ATTACHMENT 2

REVISED CLEAN TECHNICAL SPECIFICATIONS

The following pages depict the changes proposed to the existing Technical Specifications
in a re-typed format.

Figure 3.7.17-1 (page 1 of 1)
MINIMUM REQUIRED FUEL ASSEMBLY BURNUP AS A FUNCTION OF
INITIAL ENRICHMENT TO PERMIT STORAGE IN REGION 2

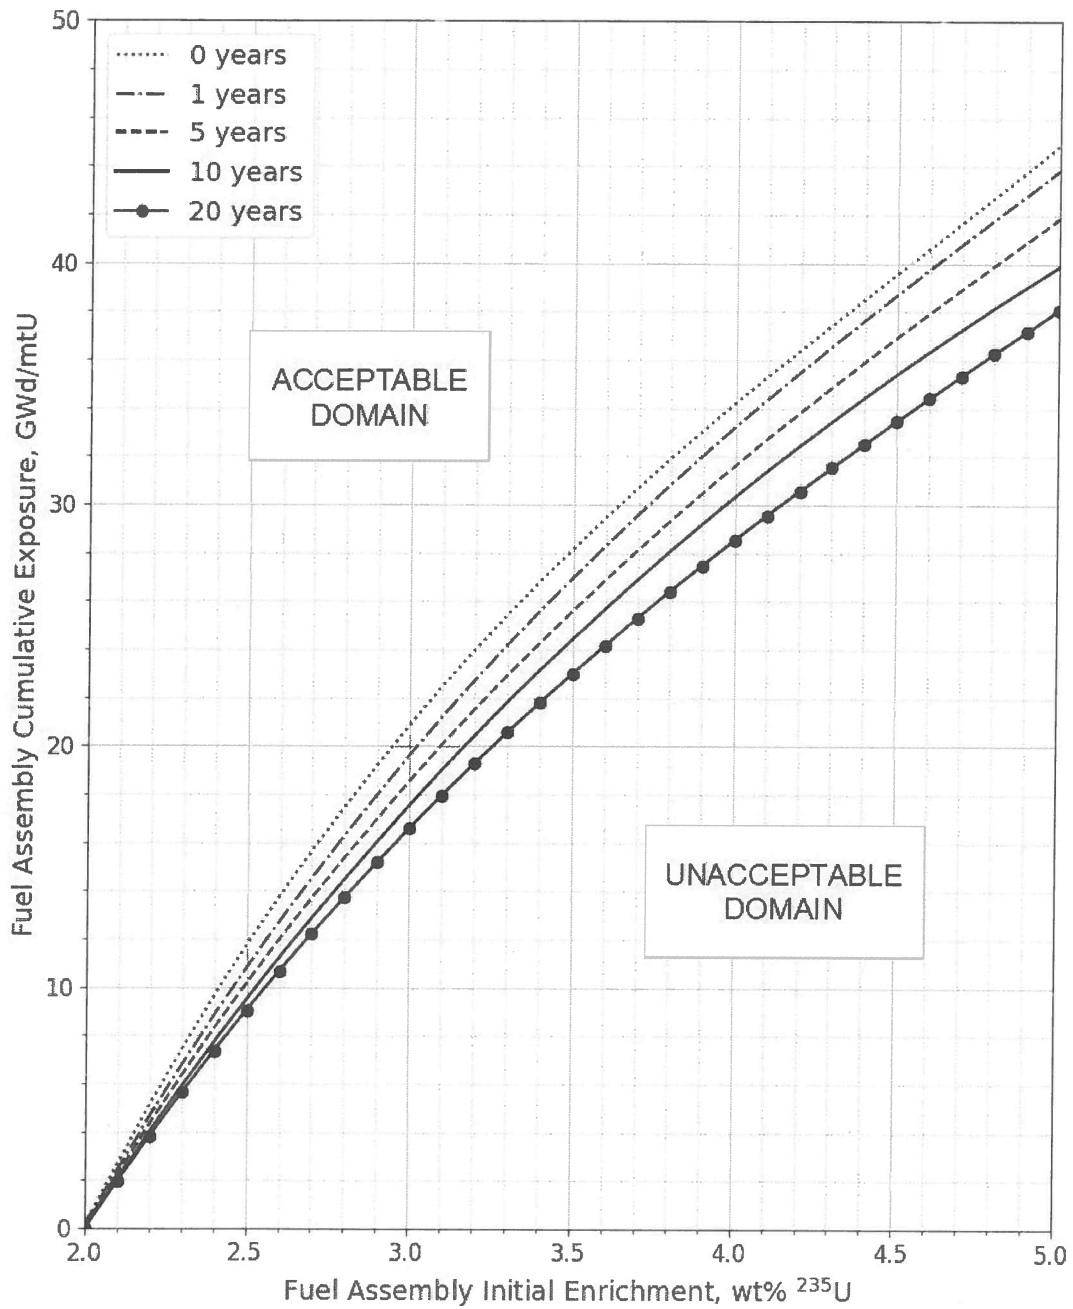
LCO 3.7.17 The combination of initial enrichment and burnup of each spent fuel assembly stored in Region 2 shall be within the Acceptable Domain of Figure 3.7.17-1.

SURVEILLANCE	FREQUENCY
SR 3.7.17.1 Verify by administrative means the initial enrichment and burnup of the fuel assembly is in accordance with Figure 3.7.17-1.	Prior to storing the fuel assembly in Region 2
